Meeting Date: May 26, 2010 Project: UO Lewis Integrative Science Building

Re : Coordinating User Group – Construction Documents

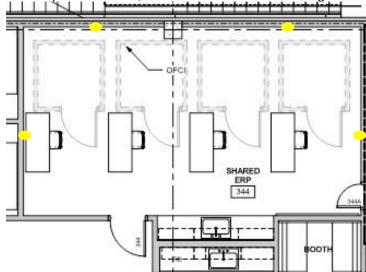
- 8. Power & Data
 - ERPS rooms need internet & true ground.
 - Outlets required above height of booth and a cable rack that runs north along the west, north and east wall.
 - Power/data outlets required on north, west and east walls in a configuration similar to this:
